Access Compliance Report

Public Rights-of-Way

Intersection ID: 48312	Main Street: ROCKY_BROOK_CT	Cross Street: TRILLIUM_FIELDS_DR	Location: SW
ADA ID: DA9486AB8F64	Ramp Type: BlendTrans1	Initial Pass/Fail: Fail	Overall Compliance: No
		Severity Score: 10

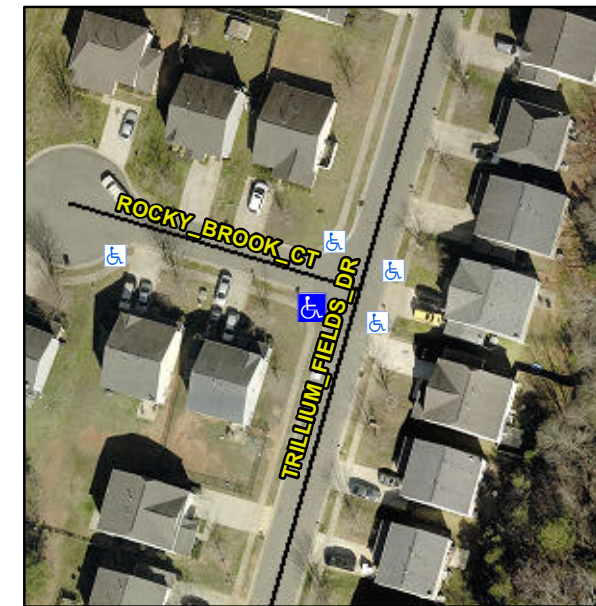
Not Found, R304.5.1, R304.5.3

Compliance	Description	Data	Compliance	Description	Data
N/A	Ramp Length (in)	48.0	Yes	BlendTrans Slope (%)	4.9
No	Ramp Width (in)	45.0	No	BlendTrans XSlope (%)	4.5
N/A	Flare Type LT	N/A	N/A	Flare Type RT	N/A
N/A	Flare Slope LT (%)	N/A	N/A	Flare Slope RT (%)	N/A
N/A	Flare Traversable LT?	N/A	N/A	Flare Traversable RT?	N/A
N/A	Landing Length (in)	N/A	N/A	DWS Provided?	N/A
N/A	Landing Width (in)	N/A	N/A	DWS Contrast?	N/A
N/A	Landing Slope (%)	N/A	N/A	DWS Length (in)	N/A
N/A	Landing X Slope (%)	N/A	N/A	DWS Full Width?	N/A
N/A	Landing Curb? (Y/N)	N/A	N/A	DWS Offset (in)	N/A
N/A	Shared Landing?	N/A			
N/A	Gutter Ponding?	N/A	N/A	Gutter Slope (%)	N/A
N/A	Gutter Lip Ht (in)	N/A	N/A	Gutter X Slope (%)	N/A
N/A	Painted X Walk1?	No	N/A	Painted X Walk2?	No
	X Walk 1 Direction	To E		X Walk 2 Direction	To N
	X Walk 1 Width (in)	N/A		X Walk 2 Width (in)	N/A
	X Walk 1 Slope (%)	0.0		X Walk 2 Slope (%)	2.3
	X Walk 1 X Slope (%)	4.9		X Walk 2 X Slope (%)	0.5

N/A	Ramp inside XWalk1?	N/A	N/A	Ramp inside XWalk2?	N/A
	Road Slope (%)	3.4		Clear Space?	N/A
	Road X Slope (%)	2.4	N/A	Clear Space to XWalk (in)	N/A
N/A	Any Obstructions?	N/A	N/A	Storm Grate/Utility Hazard?	N/A
	Obstruction Type			Storm Grate/Utility Type	
		N/A			N/A
			Yes	Surface Condition? (G/P)	Good
			No	Curb Slope (%)	13.0

Remove & Replace Curb Ramp With Two New Directional Ramps or Equivalent.
